# Access Compliance Report

## Public Rights-of-Way

### (Curb Ramps)

Intersection ID: 46492	Main Street: SHOPTON_RD_WEST	Cross Street: CASTLECOVE_RD	Location:	N
ADA ID: 1837CAD9A902	Ramp Type: PerpDiag	Initial Pass/Fail: Fail	Overall Compliance: No	Severity Score: 22.5
Codes/Mitigation Info/Possible Solution		Field Measurements/Component Compliance

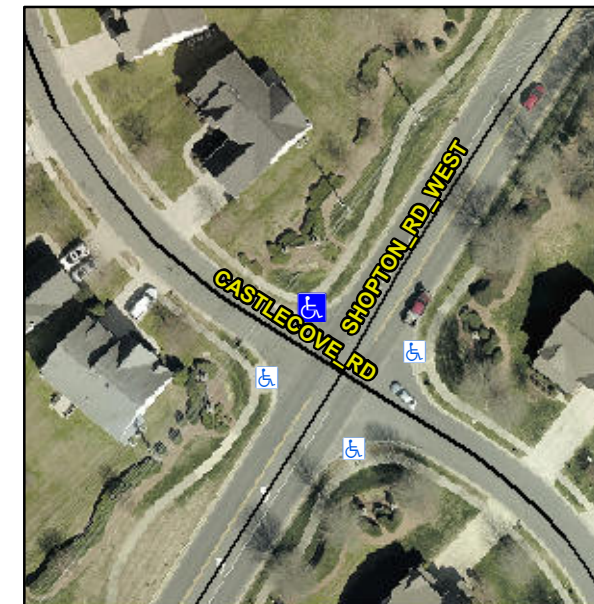
**R304.5.1, R304.2.2, R304.5.3**

Compliance	Description	Data	Compliance	Description	Data
N/A	Ramp Length (in)	49.0	No	Ramp Slope (%)	9.7
No	Ramp Width (in)	41.0	No	Ramp XSlope (%)	3.7
N/A	Flare Type LT	N/A	N/A	Flare Type RT	N/A
N/A	Flare Slope LT (%)	N/A	N/A	Flare Slope RT (%)	N/A
N/A	Flare Traversable LT?	N/A	N/A	Flare Traversable RT?	N/A
N/A	Landing Length (in)	N/A	N/A	DWS Provided?	N/A
N/A	Landing Width (in)	N/A	N/A	DWS Contrast?	N/A
N/A	Landing Slope (%)	N/A	N/A	DWS Length (in)	N/A
N/A	Landing X Slope (%)	N/A	N/A	DWS Full Width?	N/A
N/A	Landing Curb? (Y/N)	N/A	N/A	DWS Offset (in)	N/A
N/A	Shared Landing?	N/A			
N/A	Gutter Ponding?	N/A	N/A	Gutter Slope (%)	N/A
N/A	Gutter Lip Ht (in)	N/A	N/A	Gutter X Slope (%)	N/A
N/A	Painted X Walk1?	No	N/A	Painted X Walk2?	No
	X Walk 1 Direction	To SW		X Walk 2 Direction	To SE
N/A	X Walk 1 Width (in)	N/A	N/A	X Walk 2 Width (in)	N/A
	X Walk 1 Slope (%)	0.2		X Walk 2 Slope (%)	6.2
	X Walk 1 X Slope (%)	4.6		X Walk 2 X Slope (%)	2.1

**Remove & Replace Curb Ramp With Two New Directional Ramps or Equivalent.**
